POWER PLANT - CORE HARNESSSES - REVISED CLIPPING OF LOOMS E, F AND G - CATEGORY CODE 6
- MOD.ENG-71-0152

- (1) Aircraft: McDonnell Douglas MD-90
- (2) Engine: V2500-D5 Engines prior to Serial No.V20009.

Schematic view of Loom 'F' showing clipping configuration - Before alteration
Fig.2

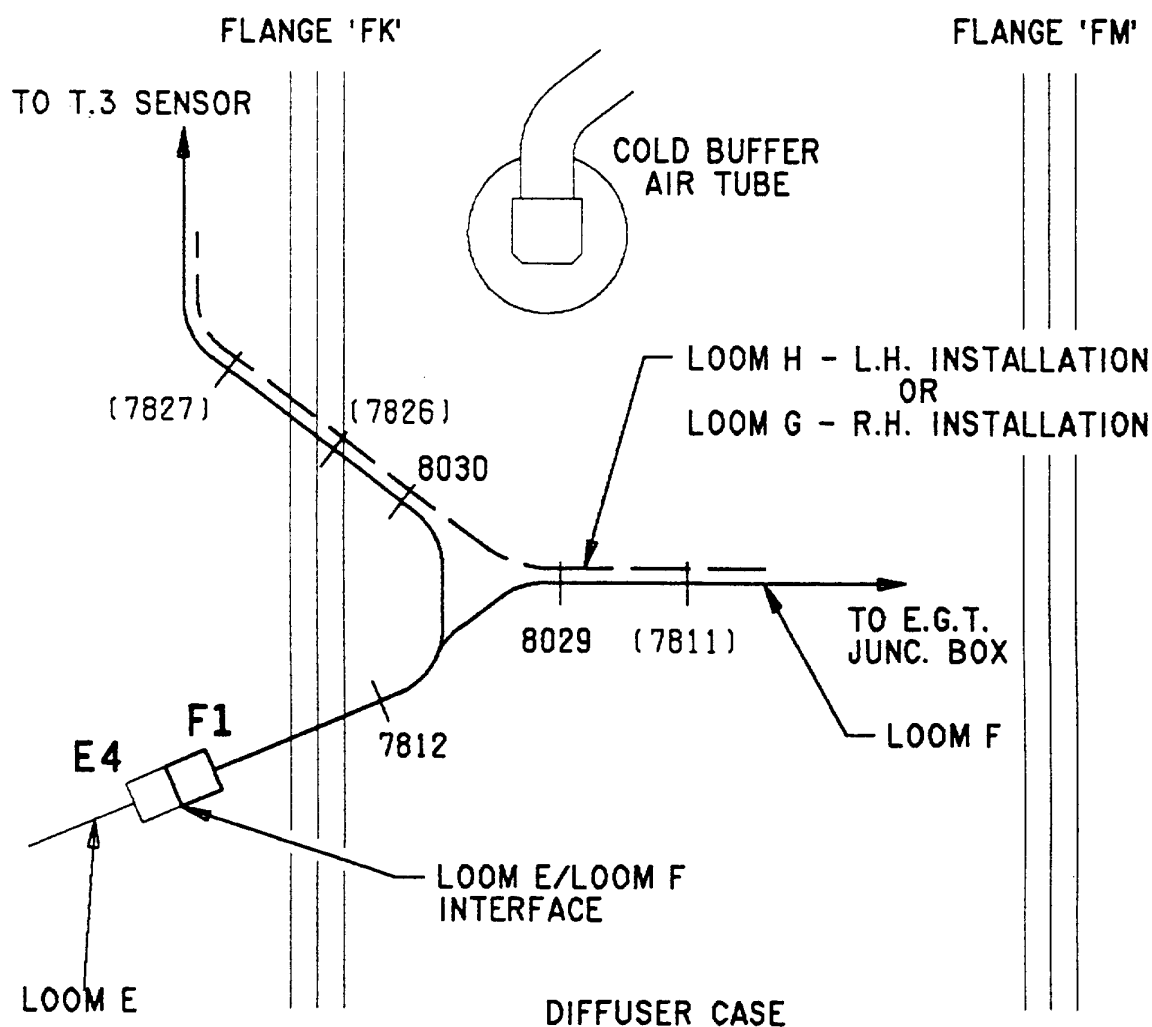
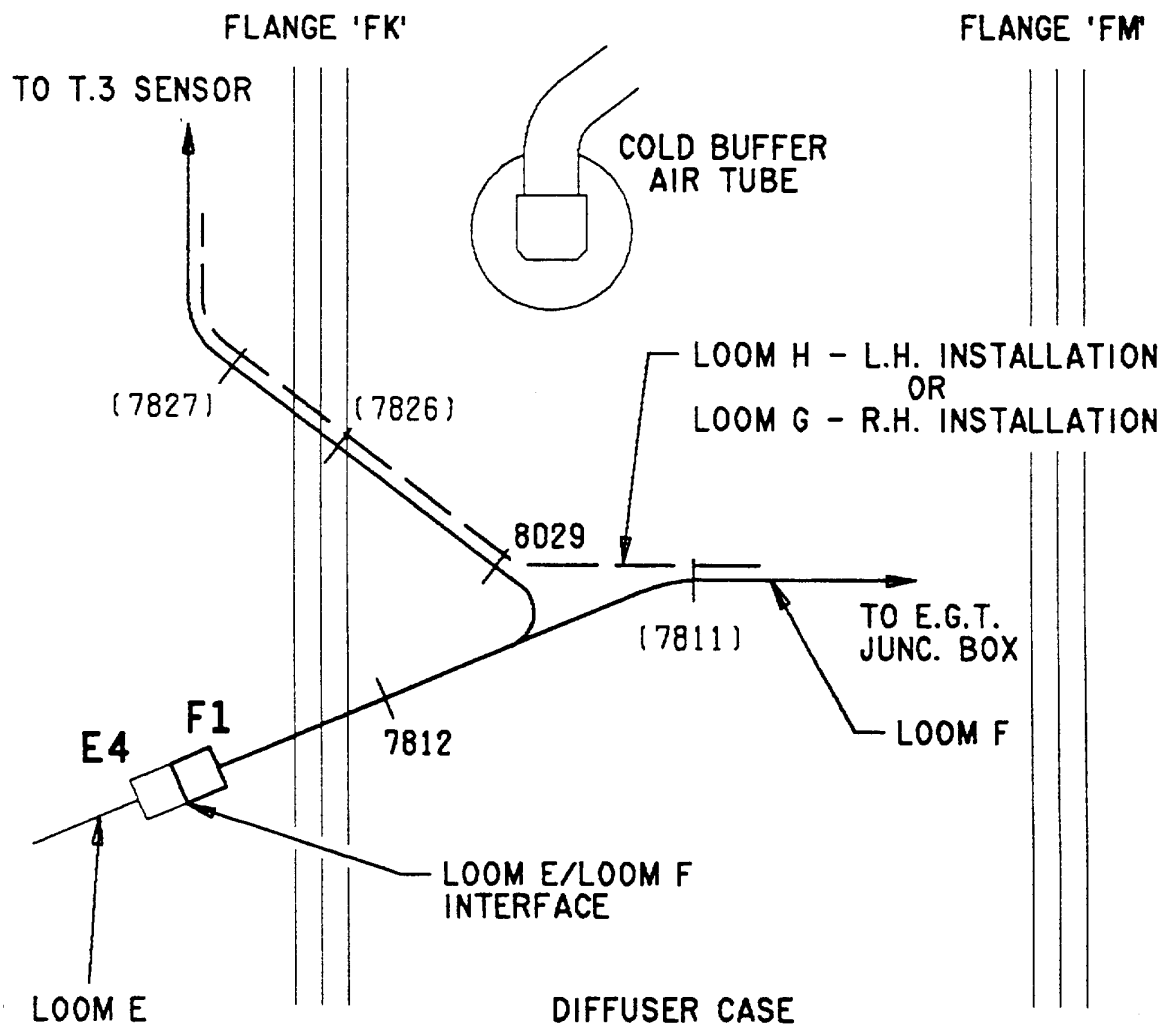
- (11) Find harness loom 'F'. Refer to Figure 1 and Figure 2.
- (12) Disassemble clipping point CP8029 sufficiently to remove harness loom 'F' to E.G.T. Junc. Box from clip. Refer to Figure 2 and Figure 10.

- (13) Disassemble clipping point CP7812 sufficiently to remove harness loom 'F' from clip. Refer to Figure 2 and Figure 7.
- (14) Disassemble clipping point CP8030, clipping point is deleted. Refer to Figure 2 and Figure 11.

Schematic view of Loom 'F' showing clipping configuration - After alteration
Fig.3

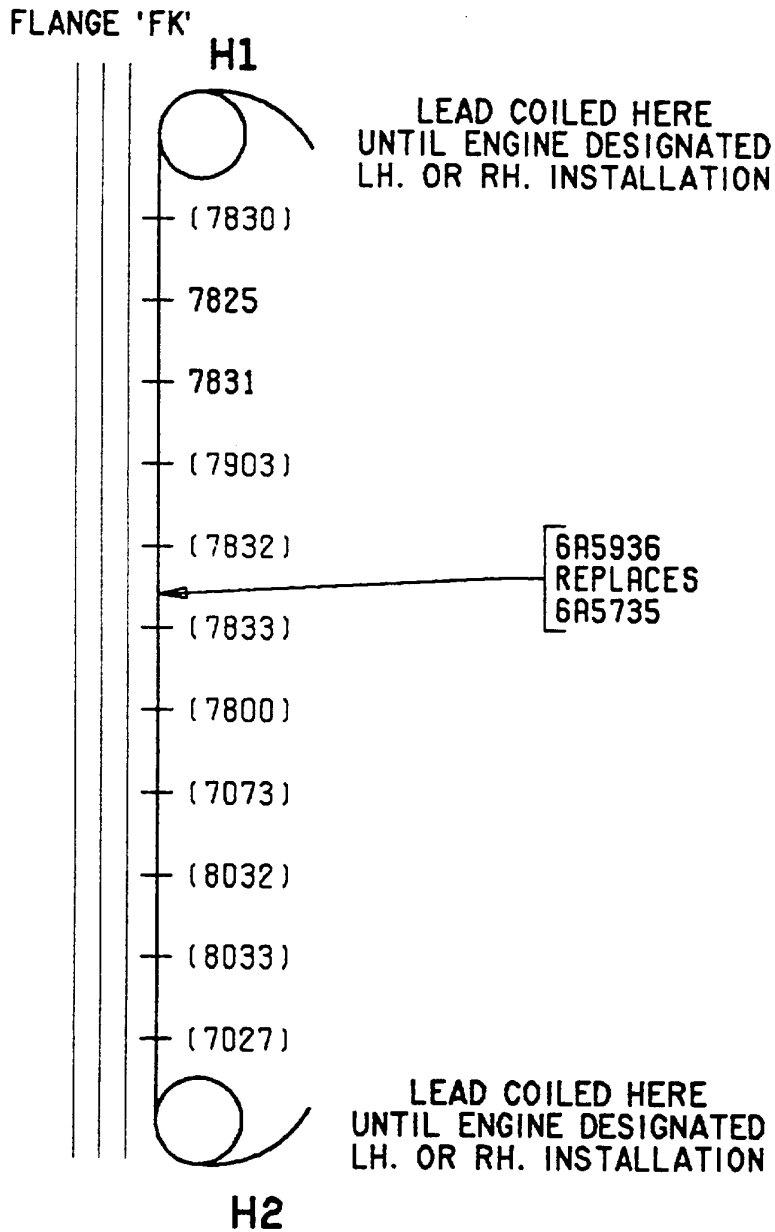
- (17) At existing clipping point CP7812 rotate the clip 180 degrees and install harness loom 'F' into clip. Assemble clipping point using existing parts. Refer to Figure 3 and Figure 7.

- (18) At existing clipping point CP8029 install harness loom 'F' to T.3 sensor into clip. Assemble revised clipping point using new 4W0112 bolt, new LK42781 spacer and existing nut. Refer to Figure 3 and Figure 10.

Schematic view of Loom 'H' showing clipping configuration - Before and after alteration
Fig.4

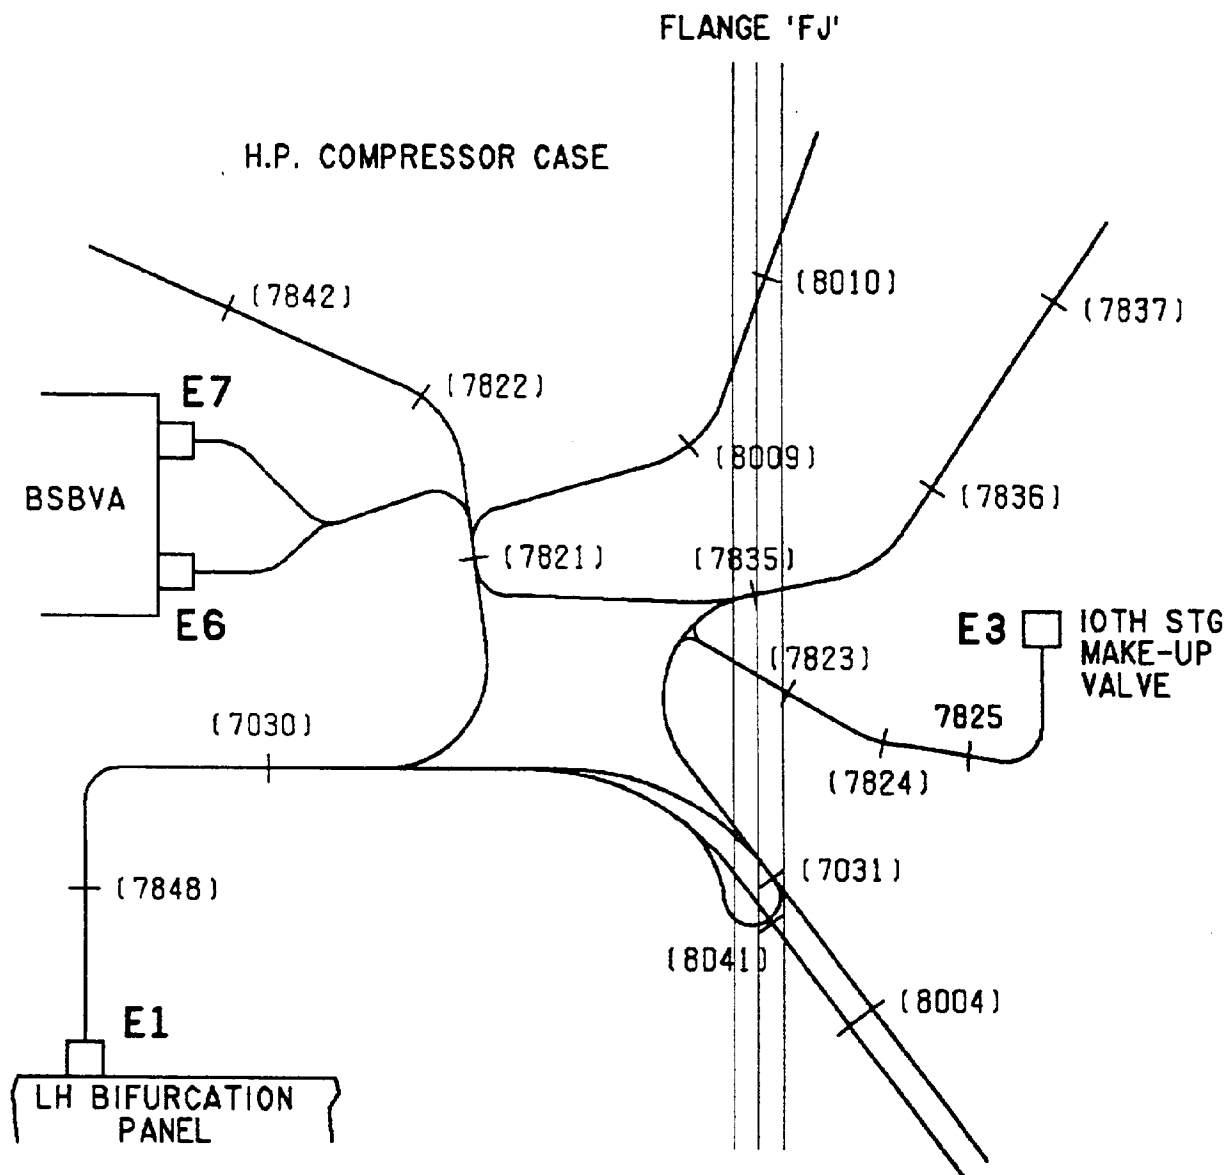
- (3) Install new 6A5936 harness loom 'H'. Refer to Figure 4.
- (4) Assemble existing clipping points CP7830, CP7903, CP7832, CP7833, CP7800, CP7073, CP8032, CP8033 and CP7027 using existing parts.

- (5) At existing clipping point CP7831, install loom 'F' into new TA025022-04 clip, install loom 'H' into new TA025022-03 clip. Assemble revised clipping point using new 4W0103 bolt and existing nut. Refer to figure 4 and Figure 9.

Schematic view of Loom 'E' showing clipping configuration - Before alteration
Fig.5

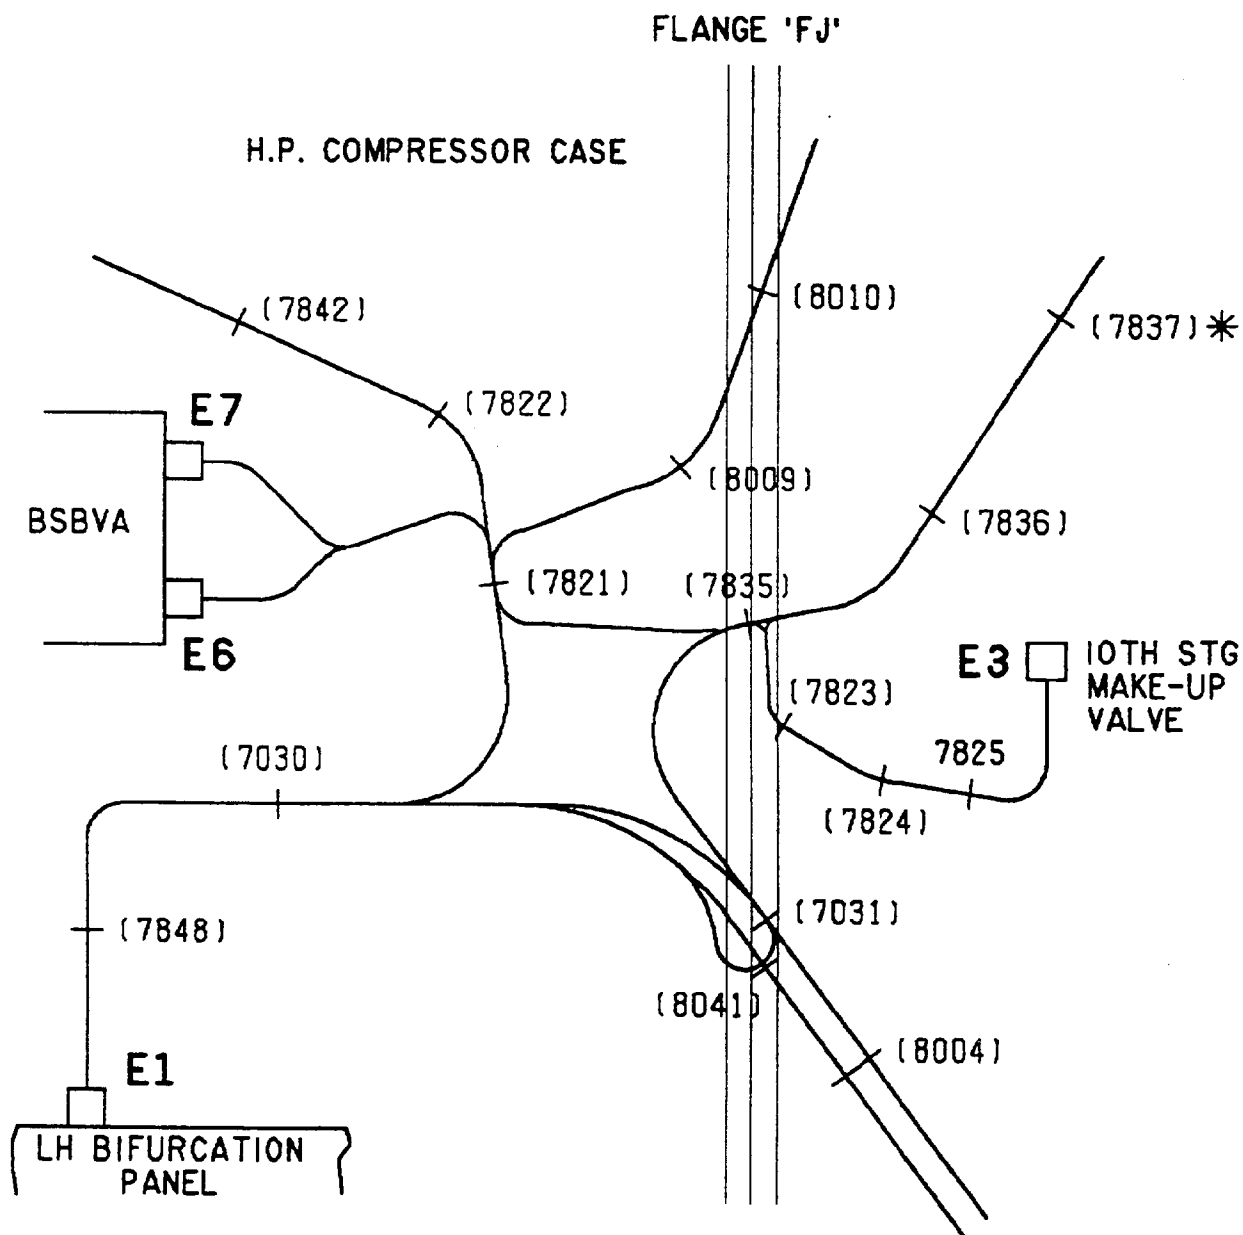
- (6) Find harness loom 'E'. Refer to Figure 1, Figure 5 and Figure 8.
- (7) Disassemble clipping point CP7825, remove AS20907 bolt and 4W0043 clip nut. Install harness loom 'H' into new TA025022-03 clip. Assemble revised clipping point using new 4W0103 bolt and new 4W0001 nut. Refer to Figure 4, Figure 5 and Figure 8.

- (8) Disassemble clipping point CP7835 sufficiently to allow the breakout limb for the 10th stage make-up valve to be installed and re-assemble clipping point using existing parts. Refer to Figure 5 and Figure 6.

Schematic view of Loom 'E' showing clipping configuration - After alteration
Fig.6

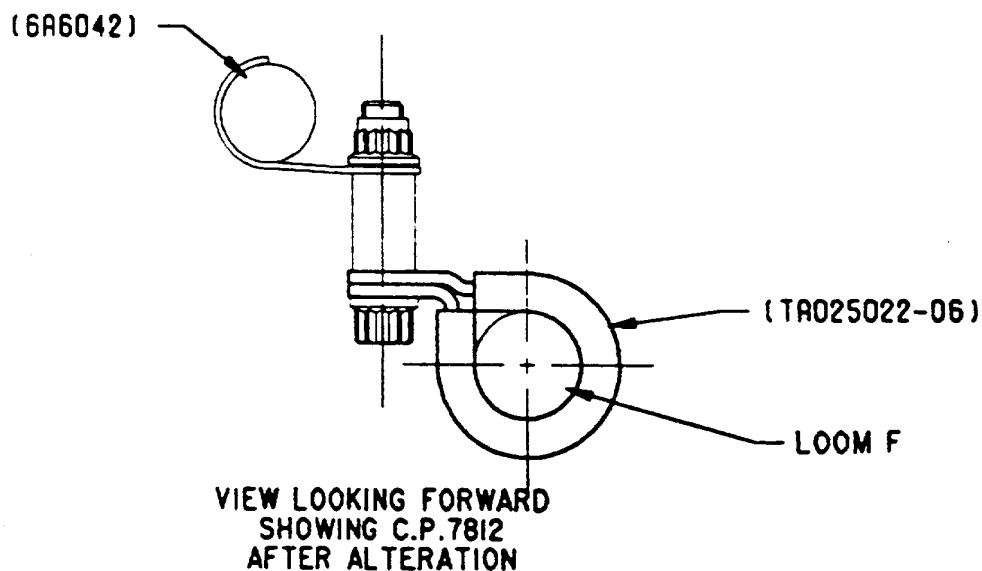
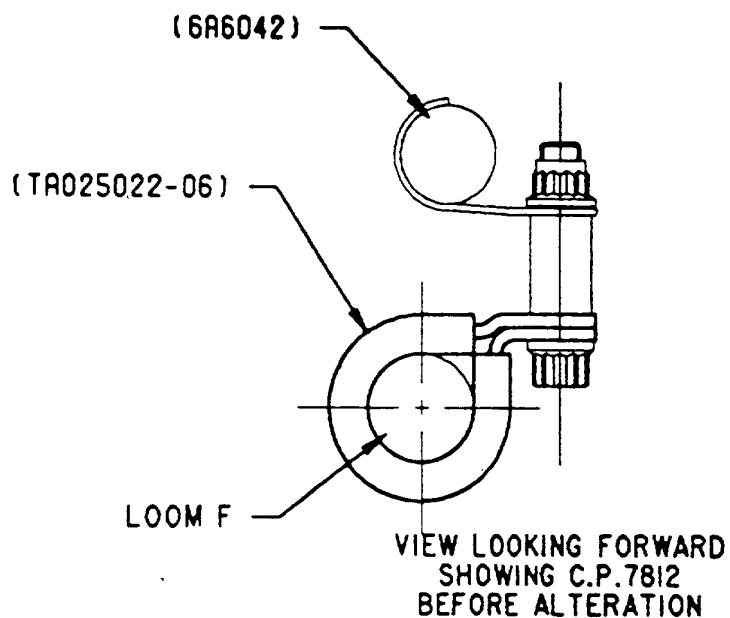
- (9) Loom 'E' datum clipping point is CP7837, check the harness is correctly positioned at CP7837, if necessary loosen off clipping points as required, reposition datum to CP7837 and re-torque clipping points to 36 to 45 lbfin (4 to 5 Nm). Refer to Figure 6.
